Access Compliance Report

Public Rights-of-Way

Intersection ID: 27363	Main Street: REA_RD	Cross Street: BALLANTYNE_COMMONS_PY	Location: SW
ADA ID: 07BA519D40DB	Ramp Type: ParaDiag	Initial Pass/Fail: Fail	Overall Compliance: No
		Severity Score: 37.5

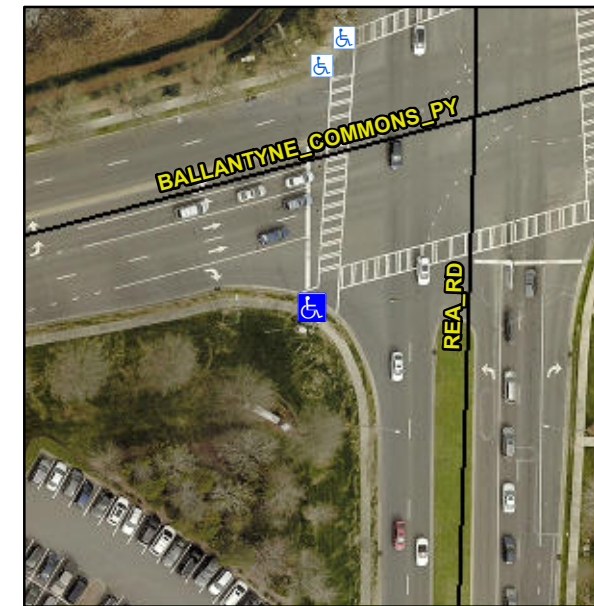
R304.3.2, R304.5.3

Compliance	Description	Data	Compliance	Description	Data
N/A	Ramp Length LT (in)	66.0	N/A	Ramp Length RT (in)	61.0
Yes	Ramp Width LT (in)	108.0	Yes	Ramp Width RT (in)	110.0
No	Ramp Slope LT (%)	8.8	No	Ramp Slope RT (%)	9.2
No	Ramp XSlope LT (%)	7.6	No	Ramp XSlope RT (%)	8.4
N/A	Landing Length (in)	N/A	N/A	DWS Provided?	N/A
N/A	Landing Width (in)	N/A	N/A	DWS Contrast?	N/A
N/A	Landing Slope (%)	N/A	N/A	DWS Length (in)	N/A
N/A	Landing X Slope (%)	N/A	N/A	DWS Full Width?	N/A
N/A	Landing Curb? (Y/N)	N/A	N/A	DWS Offset (in)	N/A
N/A	Shared Landing?	N/A			
N/A	Gutter Ponding?	N/A	N/A	Gutter Slope (%)	N/A
N/A	Gutter Lip Ht (in)	N/A	N/A	Gutter X Slope (%)	N/A
N/A	Painted X Walk1?	Yes	N/A	Painted X Walk2?	Yes
	X Walk 1 Direction	To NE		X Walk 2 Direction	To N
N/A	X Walk 1 Width (in)	124.0	N/A	X Walk 2 Width (in)	120.0
	X Walk 1 Slope (%)	0.8		X Walk 2 Slope (%)	0.1
	X Walk 1 X Slope (%)	1.0		X Walk 2 X Slope (%)	1.1
N/A	Ramp inside XWalk1?	Yes	N/A	Ramp inside XWalk2?	Yes

Remove & Replace Curb Ramp With Two New Directional Ramps or Equivalent.
